Product Change Notice (PCN)

PCN Number: **PCN-0451091R-01**

Product(s) Affected: *PJ-043-SMT-TR*

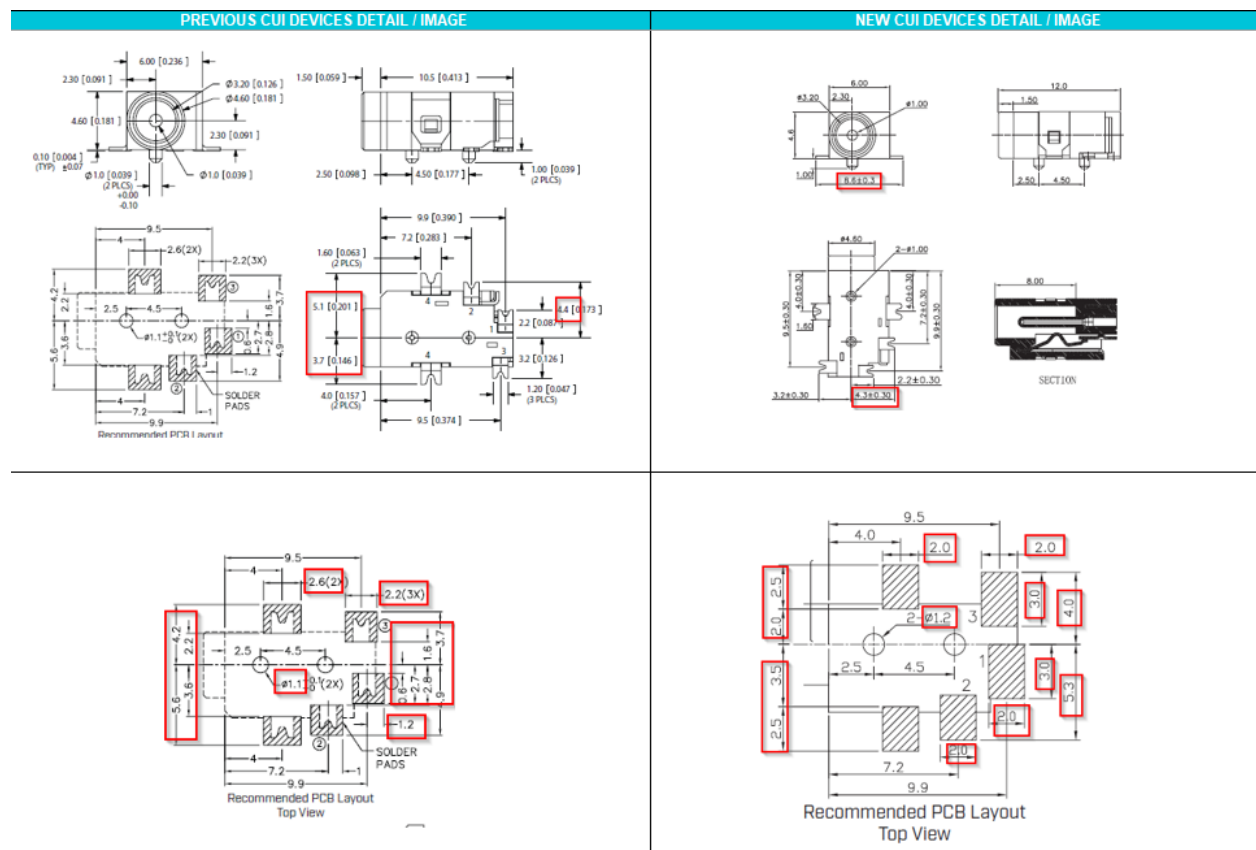
Description of Change: *Minor Housing and footprint differences. Material Change on the housing and terminals. See image Below*

PREVIOUS CUI DEVICES DETAIL / IMAGE			NEW CUI DEVICES DETAIL / IMAGE		
	MATERIAL	PLATING	DESCRIPTION	MATERIAL	PLATING/COLOR
center pin	brass	silver	center pin	brass	tin
terminal 1	brass	silver	terminal 1	brass t-0.25	tin
terminal 2	copper alloy	silver	terminal 2	SUS301 t-0.25	tin
terminal 3	brass	silver	terminal 3	brass t-0.25	tin
shield	cold rolled steel	nickel	shield	brass t-0.25	tin
plastic	PA6T or equivalent		housing	PA9T (UL94V-0)	black
